# CITY OF ALBUQUERQUE

**Re: Madison Middle School, 3501 Moon NE,  
(G-20/D034)  
Approval of Permanent Certificate of Occupancy,  
Engineer's Revised Stamp Dated: 9-27-09  
Engineer's Certification Date: 3-12-09**

PROJECT TITLE: MADISON MIDDLE SCHOOL ZONE MAP/DRG. FILE#: G-20/D039

**Re: Madison Middle School, 3501 Moon NE, Traffic Circulation Layout  
Engineer's Stamp dated 5-25-05 (G20-D34)**

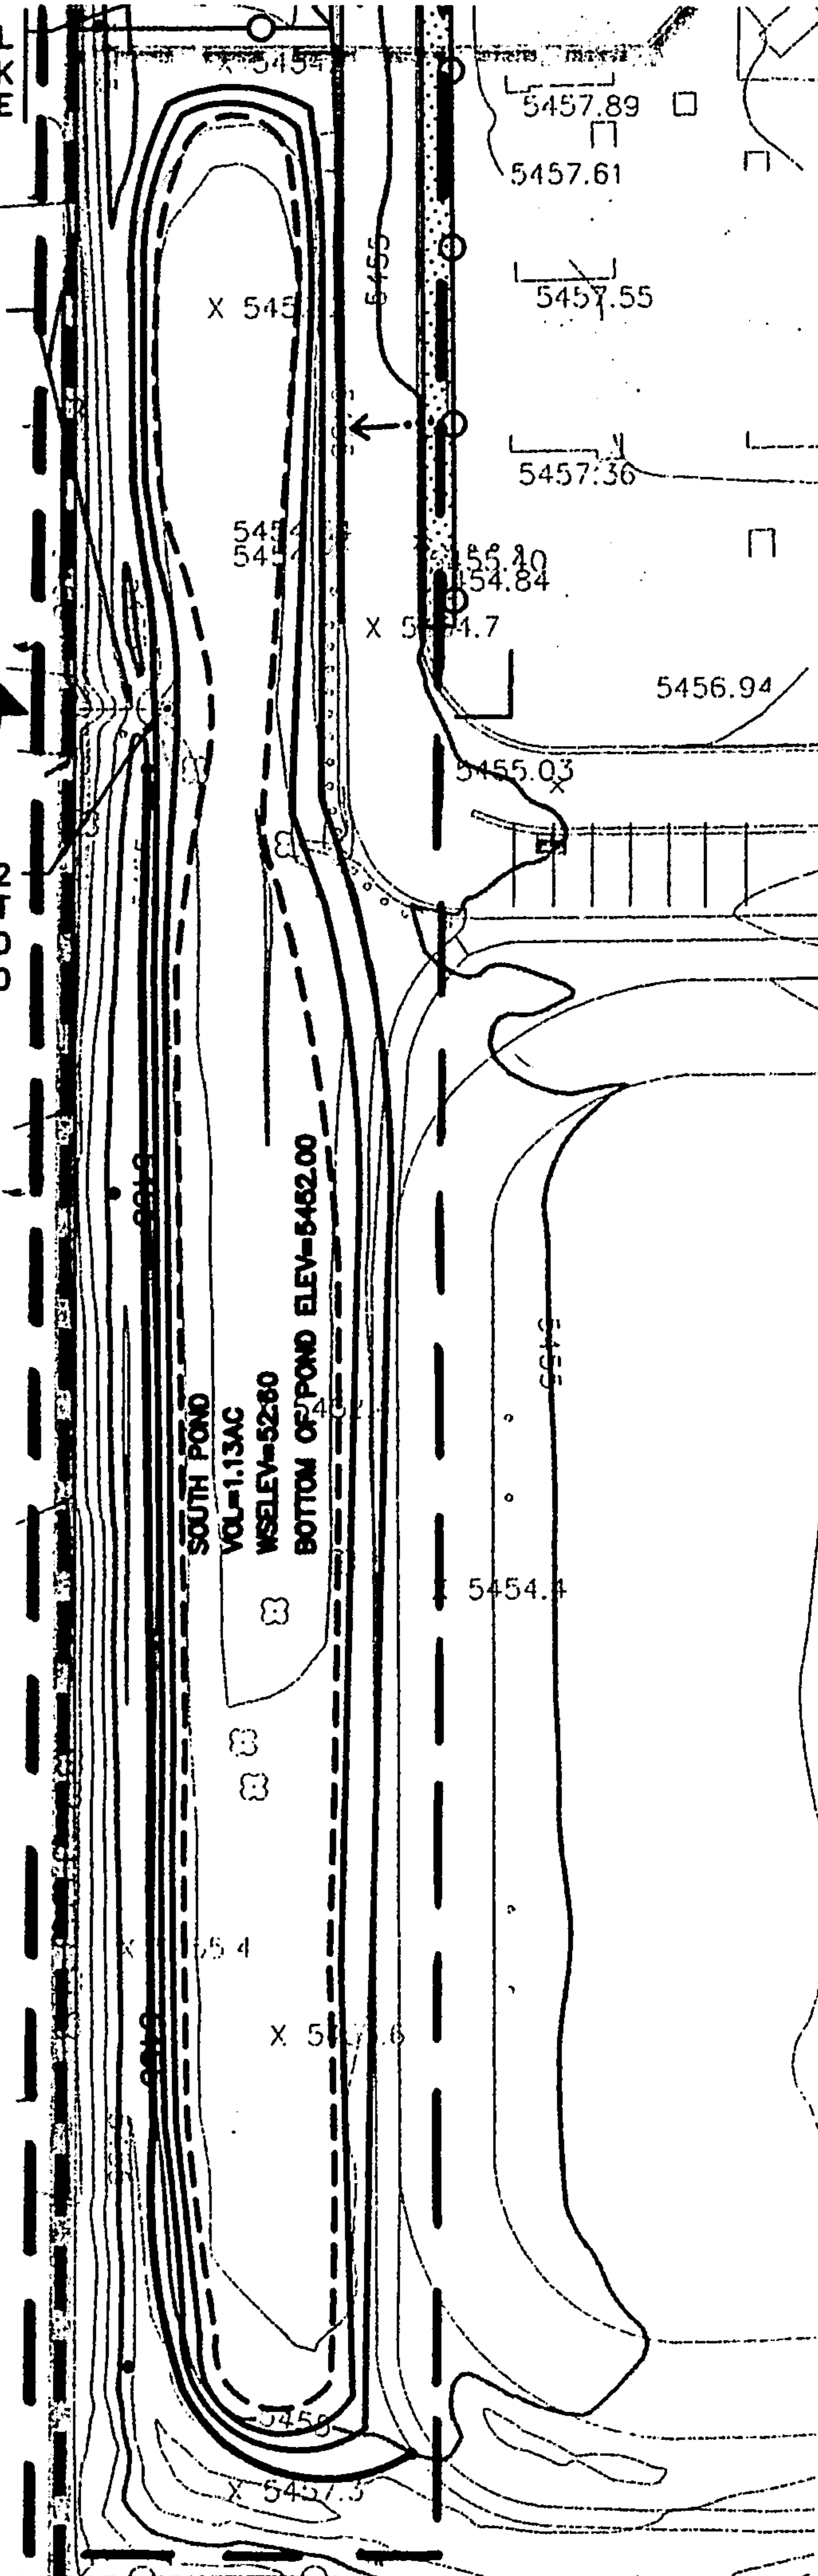
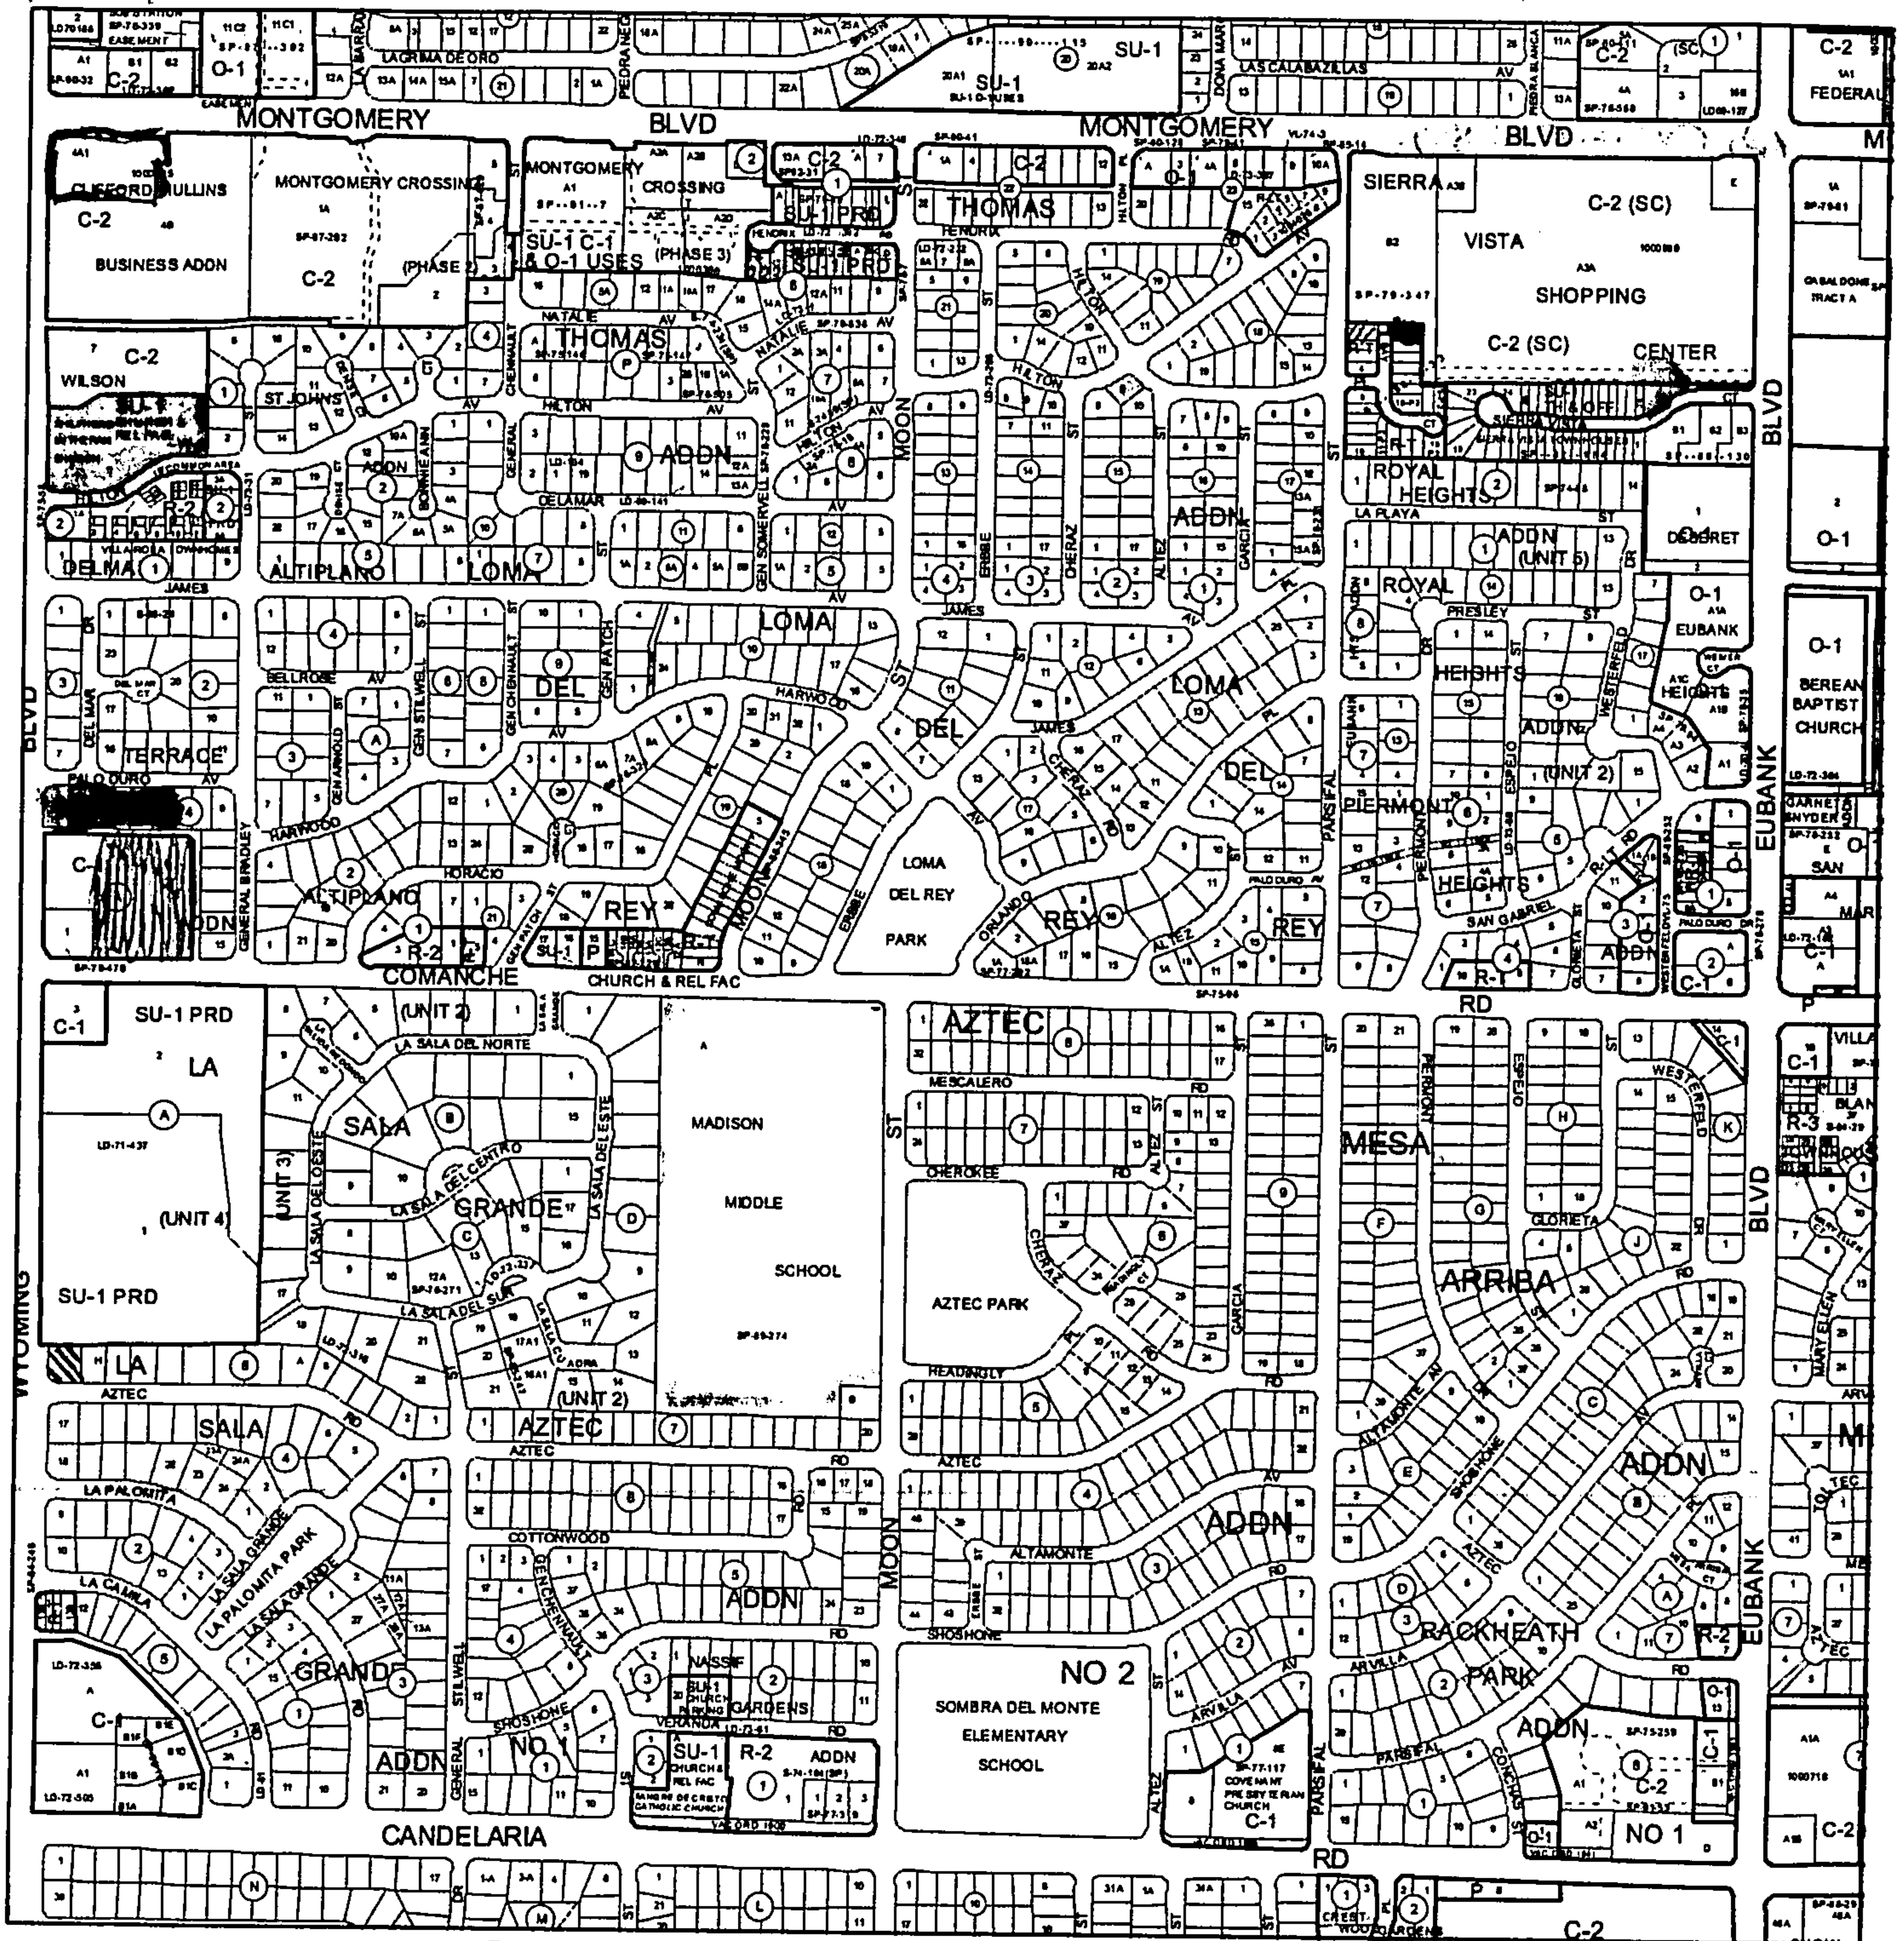
1. Show the flood plain crossing the site. A LOMR may be prudent.
2. Classroom and library additions are shown on the grading and drainage plan. To build these additions, you must first apply for a building permit, not just a paving permit. Please apply for a building permit, which includes a \$50 review fee, at your next submittal.

3. Provide the finish floor elevations for the proposed building additions.
4. Define existing versus proposed drainage infrastructure.
5. Please add the dimensions of the new north pond and show the infrastructure that drains this pond. What street does the south pond drain to?

6. The inlet at the end of Curve E will have to be relocated.
7. Reference is made to the Monte Vista Elementary School in your conclusion; please rectify this.

INSTALL 2'-0"  
CURB CUT WITH  
6'-0" WIDE  
RIPRAP RUNDOWN

EXISTING DISCHARGE  
PIPE TO BE EXTENDED  
BEYOND RIGHT OF  
WAY TO EXISTING  
ROADWAY SEE EXHIBIT  
'A'. INV(OUT) TO  
MATCH EXISTING TOP  
OF ASPHALT

INSTALL 49.75LF 18"  
CLASS III RCP  
W/STD END SECTIONS  
INSTALL  
10W15'LONGX18"H  
TYPE VL RIPRAP  
INV(UP)=57.00  
INV(DN)=53.57

EXISTING DISCHARGE  
PIPE TO BE EXTENDED  
BEYOND RIGHT OF  
WAY TO EXISTING  
ROADWAY SEE EXHIBIT  
'B'. INV(OUT) TO  
MATCH EXISTING TOP  
OF ASPHALT

Sheet No. C-7A of       
Job. No.       
By MTW Date 4/6/92

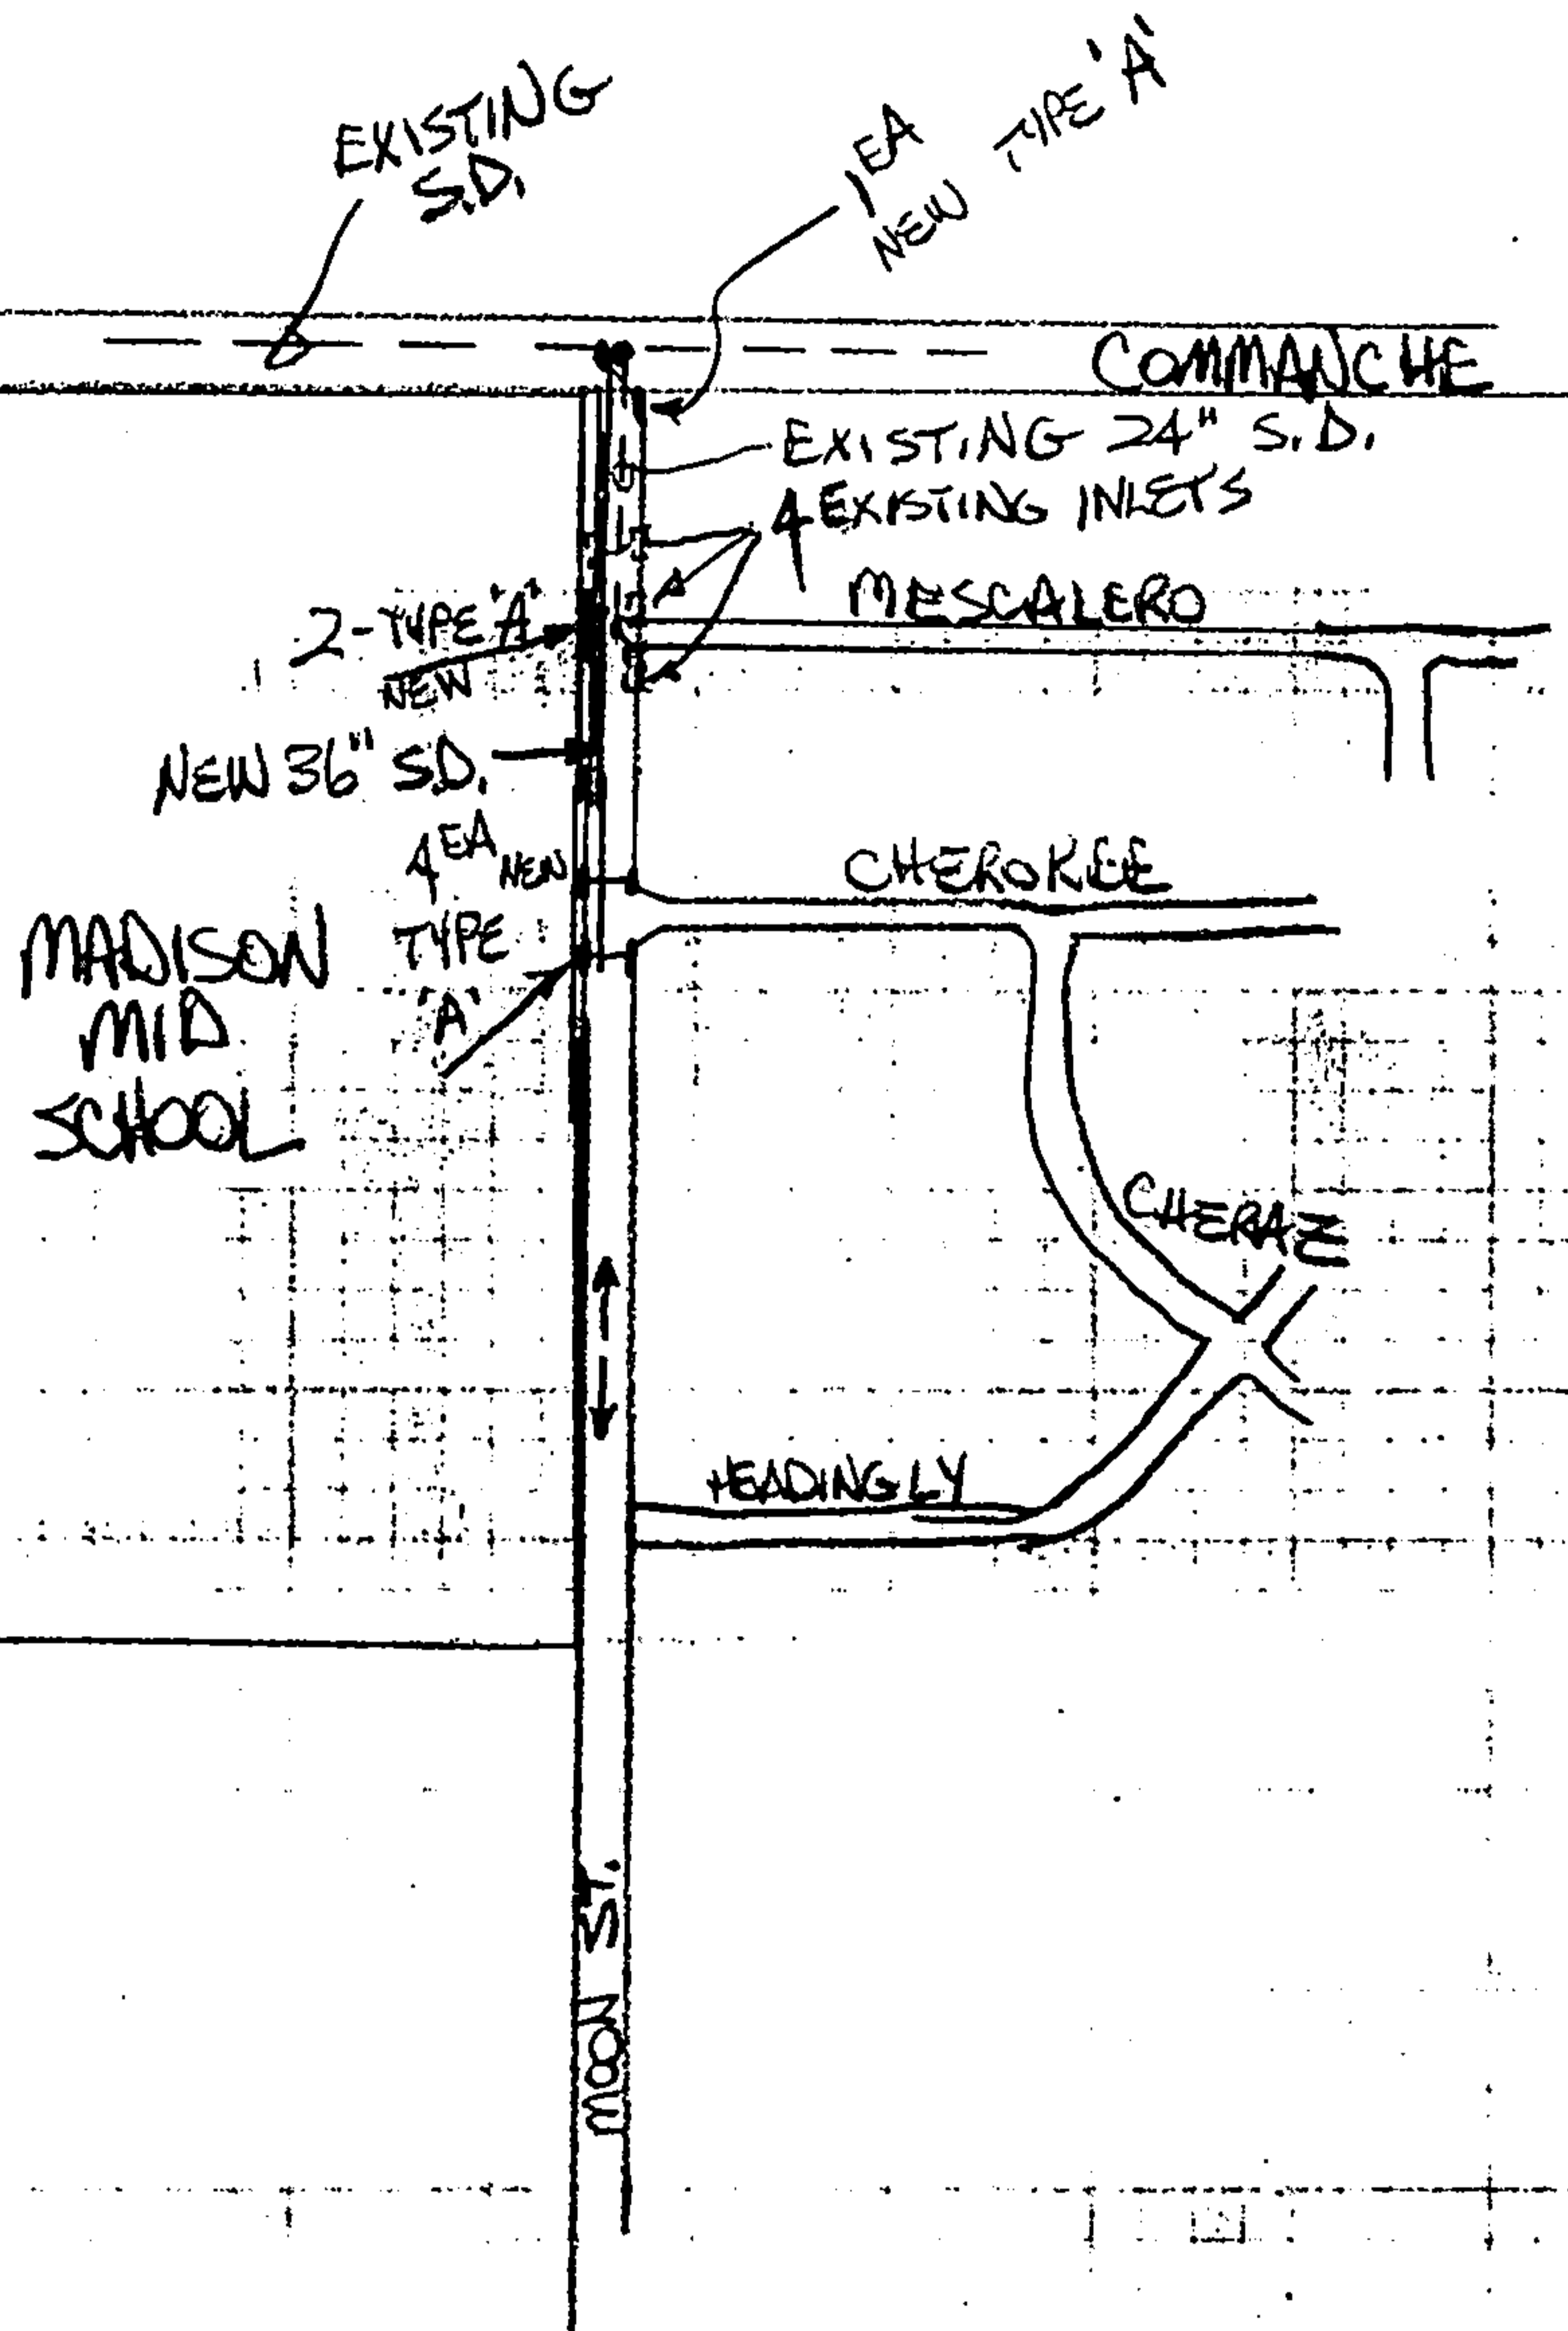
Verify in field.  
plans say  
 $S = 0.003$

Field  
Verify  
IE's
